Request for Additional Information No. 306, Supplement 1

U.S. EPR Standard Design Certification

Docket No. 52-020

Application Section: FSAR Ch 3

Figure 03.08.01-41-1—Boundary between Containment Structure and Crane Assembly

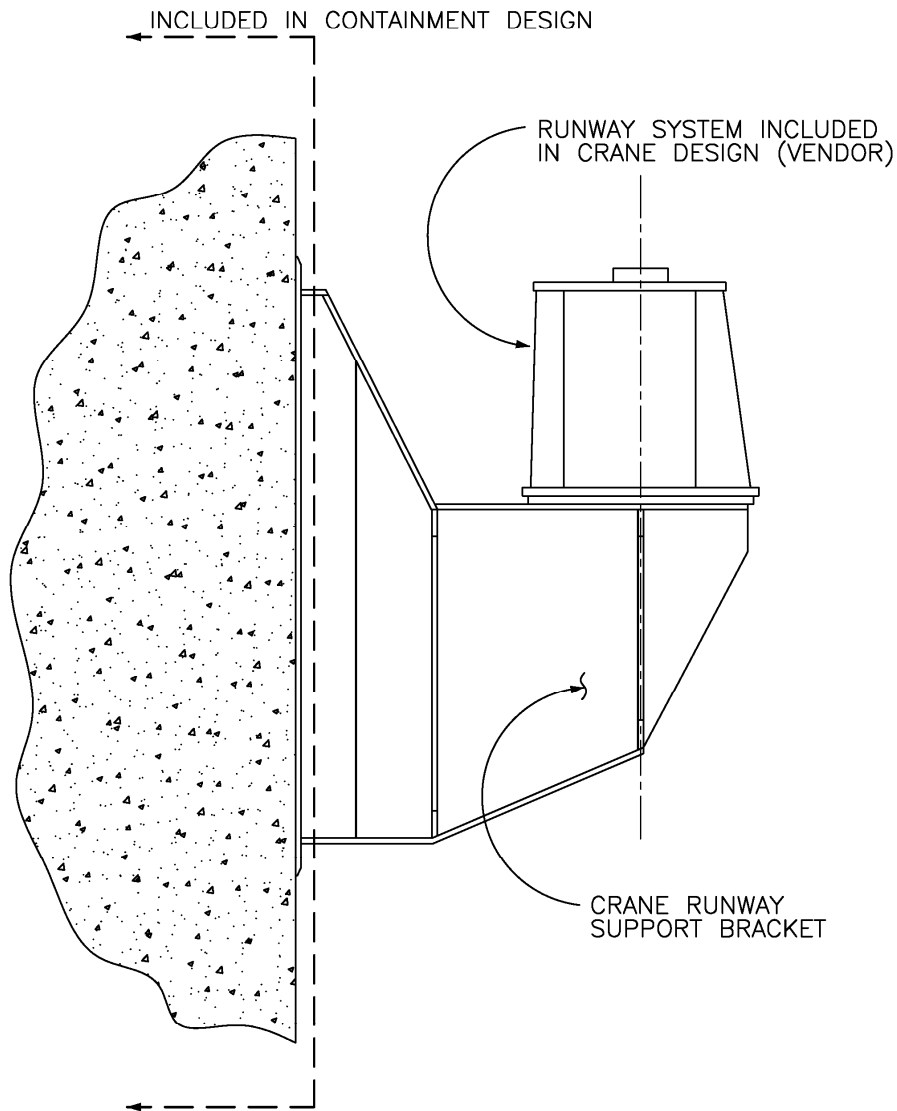
The response to item (1) of this RAI explains that the jurisdictional boundary between the polar crane assembly and the RCB is the location at which the crane runway system (girders) attaches to the crane runway support brackets. The crane support brackets are included in the design of the RCB. The RAI response provides a detail showing the jurisdictional boundary. The description of the jurisdictional boundary between the polar crane assembly and the RCB, which is discussed in the RAI response, needs to be included in the appropriate locations of the FSAR Section 3.8.

The response to item (3) of this RAI indicates that the crane girder and intervening structural steel members will be designed in accordance with the requirements for design and materials specified in AISC N690. Since the RAI response indicates that the intervening structural steel members (i.e., crane support brackets) are within the jurisdictional boundary of the RCB, explain why AISC N690 is utilized rather than the applicable ASME Code for containment. It should be noted that ASME Code, Section III, Division 2, Subsection CC, indicates that the design of steel members not backed by concrete shall meet the requirements of NE-3000 and Subsection NCA. Also, Article NE-1000 of ASME Code, Section III, Division 1, explains the jurisdictional boundary for the containment and any attachments to the containment, and provides a figure with typical examples. The jurisdictional boundaries identified in the RAI response do not appear to be consistent with the jurisdictional boundaries given in the ASME Code. Therefore, explain the basis for the ASME Code jurisdictional boundaries described in the RAI response with respect to the crane support brackets.

The design of the polar crane support brackets is not included in the jurisdictional ASME containment design boundary. Figure 03.08.03-11-1 of the Response to RAI 155, Question 03.08.03-11, has been revised for clarity and is included with this response as Figure 03.08.01-41-1.

The use of AISC N690 is appropriate in the design of the polar crane support brackets. The U.S. EPR FSAR description of the ASME containment design boundary excludes the design of the crane support brackets, and no changes are required.
